ORIGINATION FORM

Proposed Revisions to a Standard Plans Index
(Please provide all information — Incomplete forms will be returned)

Index Number: 515-052
Sheet Number (s): 5
Index Title: Pedestrian/Bicycle Railing (Steel)

Sheet 5- Added knuckled selvage as an option to the chain-link railing option

TYPE 2 - CHAIN-LINK (Continuous Infill Panel)

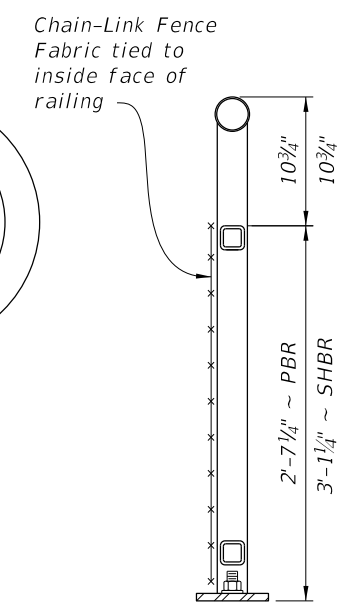
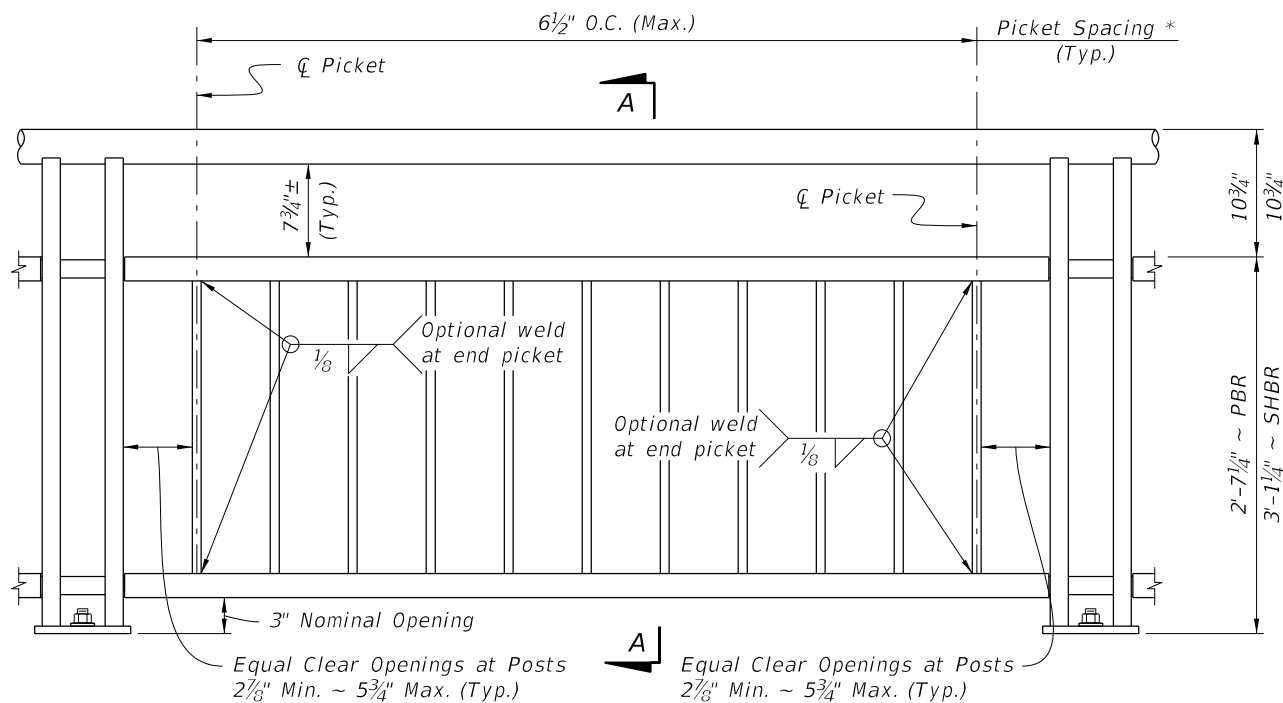
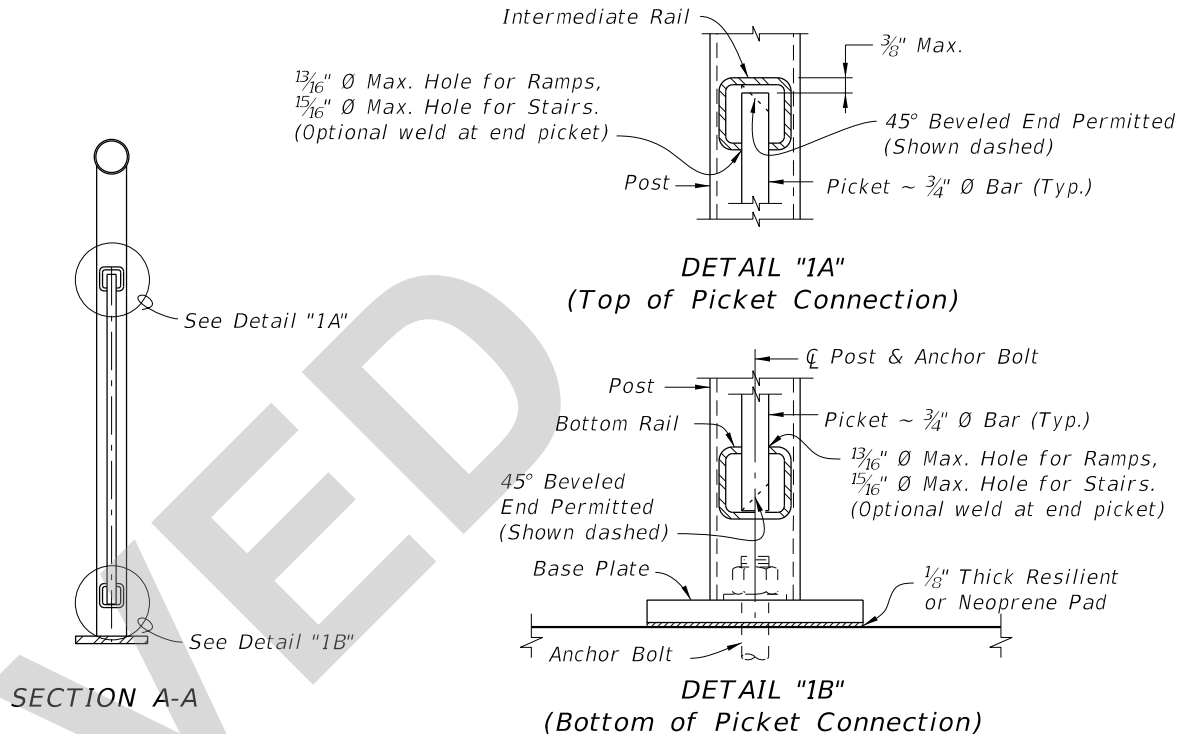
The selvage requirements detailed on Index 515-052 were based on a conservative approach to secure the bottom edge. Using knuckle selvage top and bottom would be acceptable.

TABLE 2 - CHAIN-LINK PANEL COMPONENT MATERIALS		
COMPONENT	ASTM	COMPONENT INFORMATION
Chain-Link Fence Fabric (2" mesh with knuckled top and bottom selvage)	A 392	Zinc-Coated Steel - No. 9 gage (coated wire diameter), Class 2 Coating
	A 491	Aluminum-Coated Steel - No. 9 gage (coated wire diameter)
	F 668	Polyvinyl Chloride (PVC) Coated Steel - No. 9 gage Zinc-Coated Wire (metallic-coated core wire diameter) ~ See Plans for specified color of PVC.
Tie Wires	F 626	Zinc-Coated Steel Wire - No. 9 gage with coating to match Chain-Link Fence Fabric.
Tension Bars	F 626	3/16" (Min. thickness) x 3/4" (Min. width) x 2'-3' (Min. height) Steel Bars
Miscellaneous Fence Components	F 626	Zinc-Coated Steel
